GENERAL APPLICATION

Location Address: 1942 Taylor Street, Hollywood, FL 33020

Explanation of Request: Multi Family Dwelling

SUBJECT: Preliminary Site Plan review for an 18-unit residential development
Owner/Applicant: MEC INVESTMENTS INC
Address/Location: 1942 Taylor St
Net Size of Property: 10,759 sq. ft. (0.25 acres)
Land Use: Regional Activity Center (RAC)
Zoning: North Downtown High Intensity Mixed-Use District (ND-3)
Present Use of Land: Residential
Year Built: 1925 - 1954

SHEET NUMBER:
LA-T1

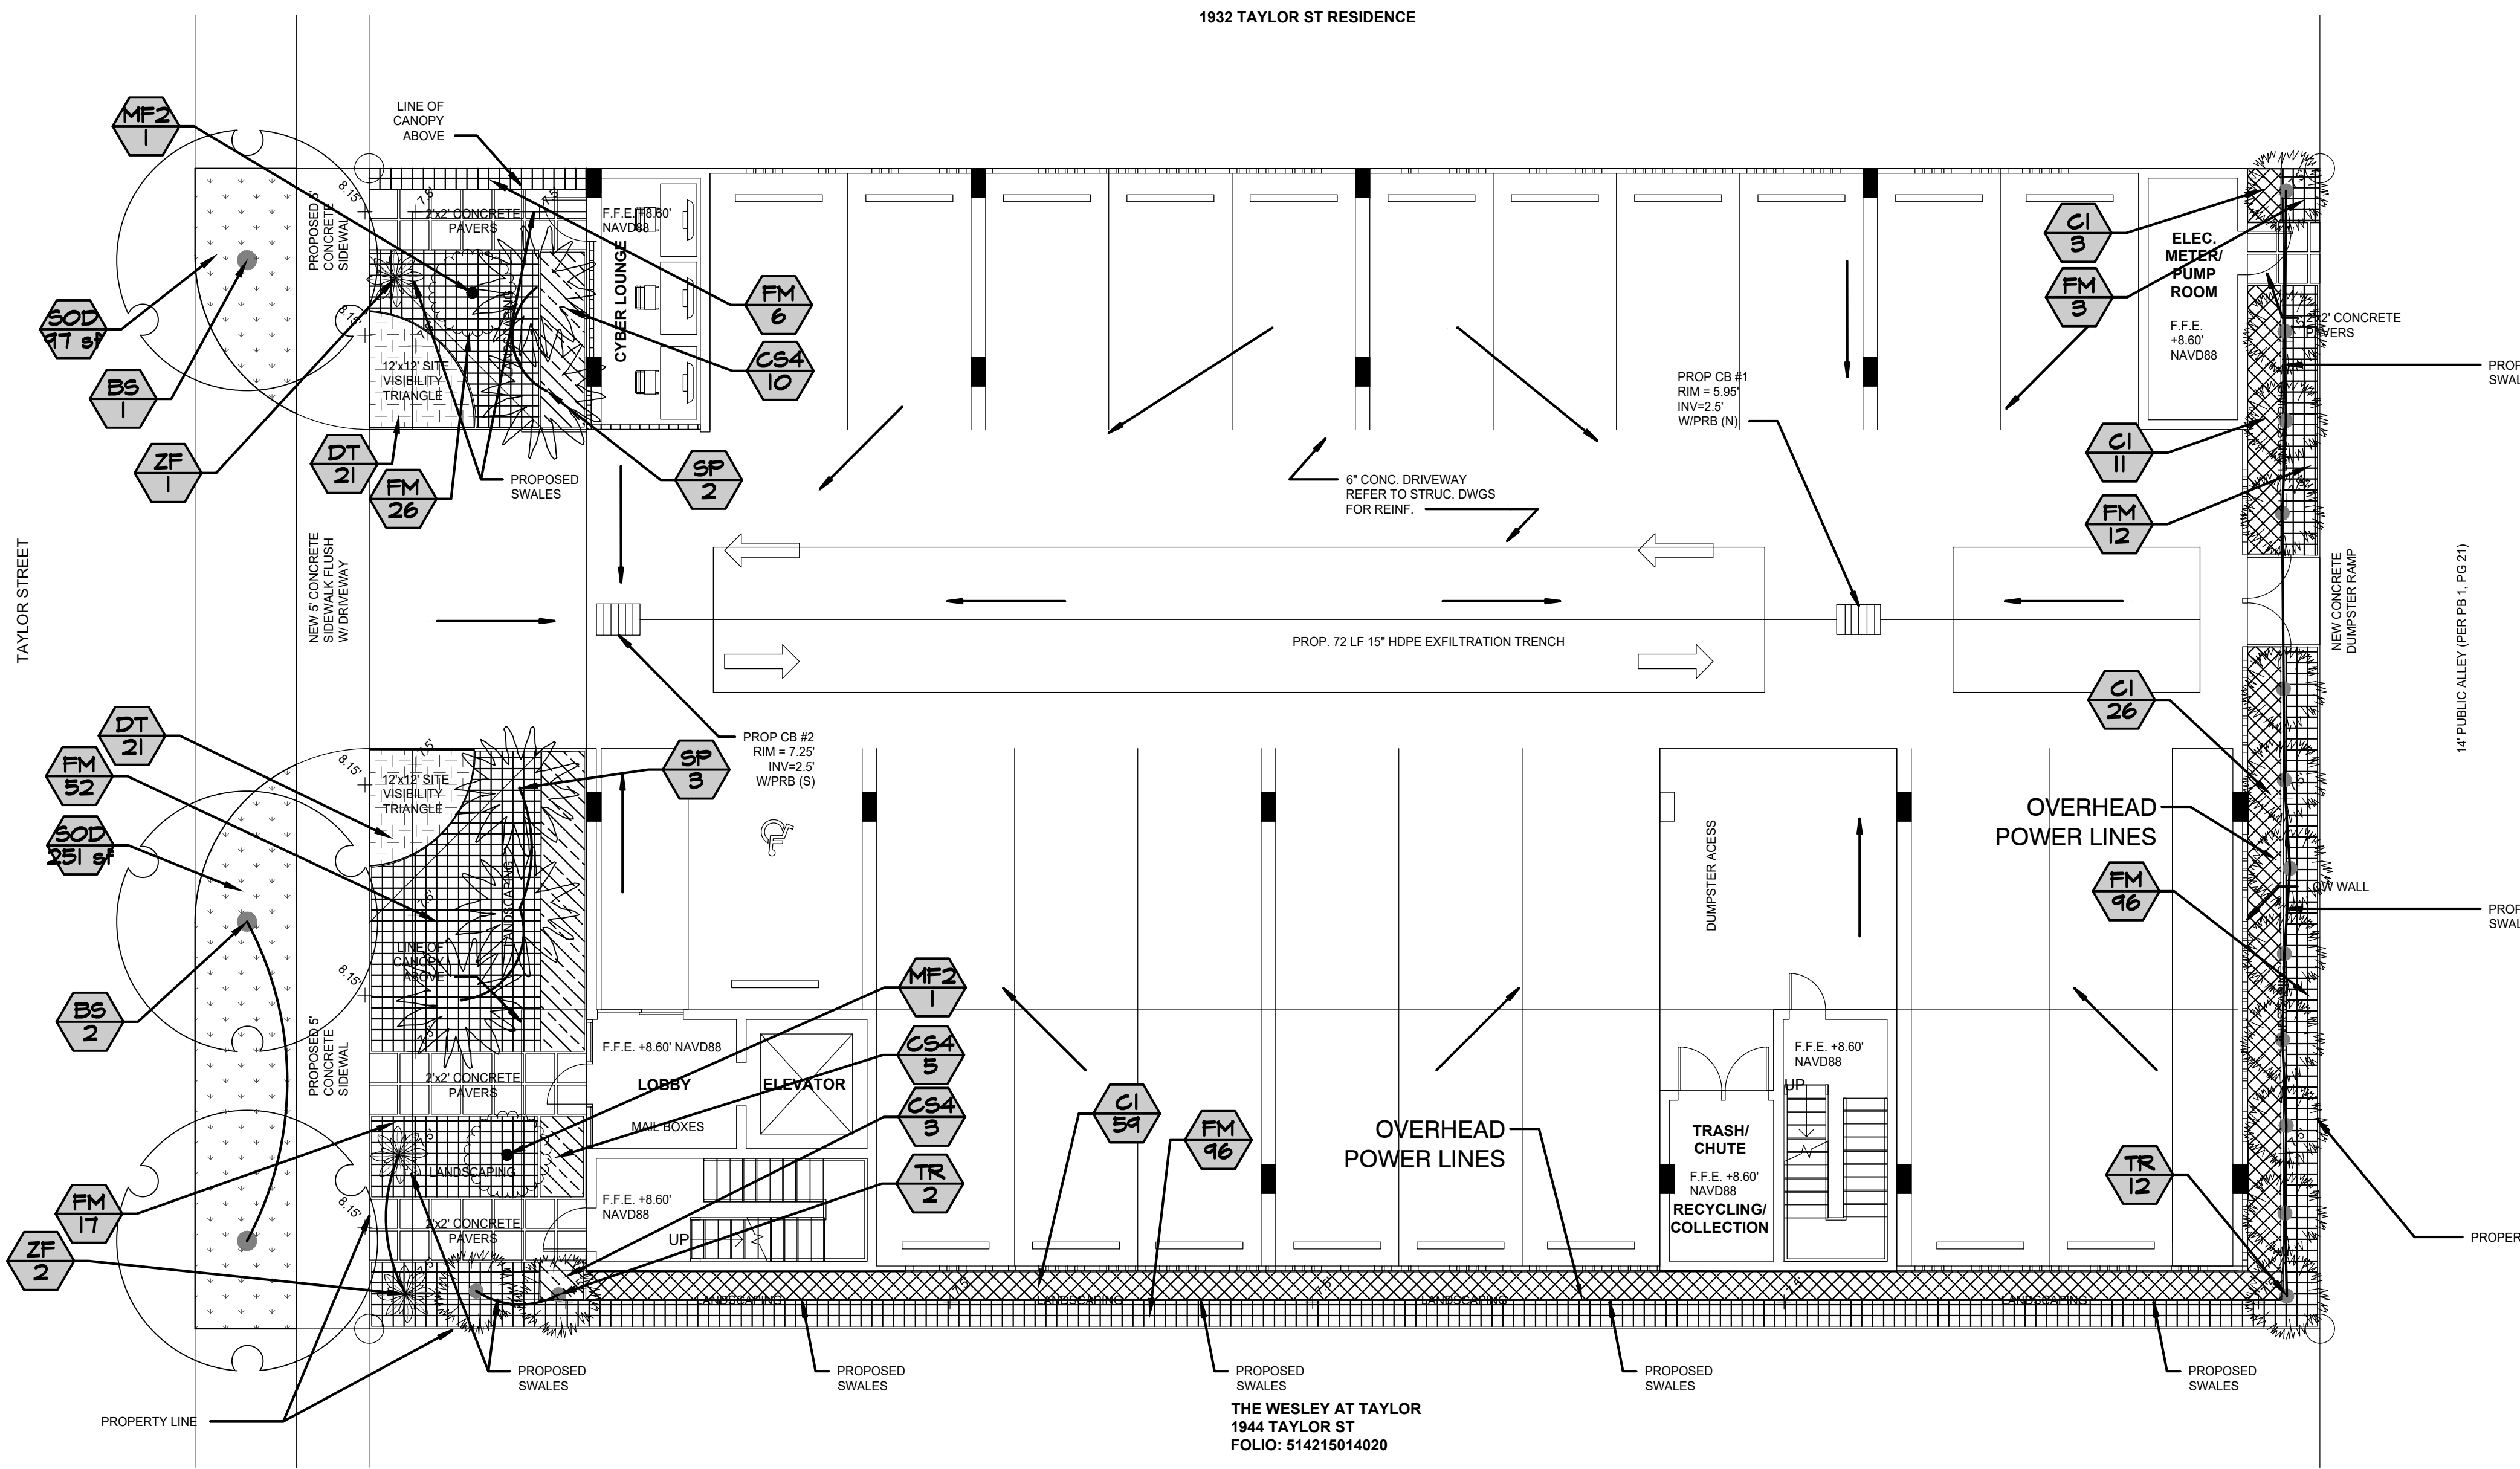
1. Satellite images show existing trees/palms. **Refer to Landscaping drawings.**
2. Provide a Tree disposition plan and landscape plan on separate sheets by a registered professional licensed Landscape Architect in the State of Florida that compliments the building architecture and uses, provides for shade, beautifies the site, accentuates site features, and serves as a buffer where appropriate. **Refer to Landscaping drawings.**

4. Provide sight triangles on plans at intersection of driveway and property line – Sec. 155.12 (d)
Refer to Landscaping drawings.
5. Native plant requirements; 60% trees, 50% shrubs – Sec. 3.4. **Refer to Landscaping drawings.**

6. Label all sides of property whether there are 'Existing Overhead Powerlines' or 'No Overhead Powerlines'. Provide FPL approved trees for planting under powerlines. **Refer to Landscaping drawings.**

7. Add note: 'Trees and Palms shall not be removed without first obtaining an approved Tree Removal Permit from the City of Hollywood.' **Refer to Landscaping drawings.**

9. Add note: All landscaping shall be warranted for 1 year after final inspection. **Refer to Landscaping drawings.**

11. Add note: 100% irrigation coverage shall be provided. **Refer to Landscaping drawings.**
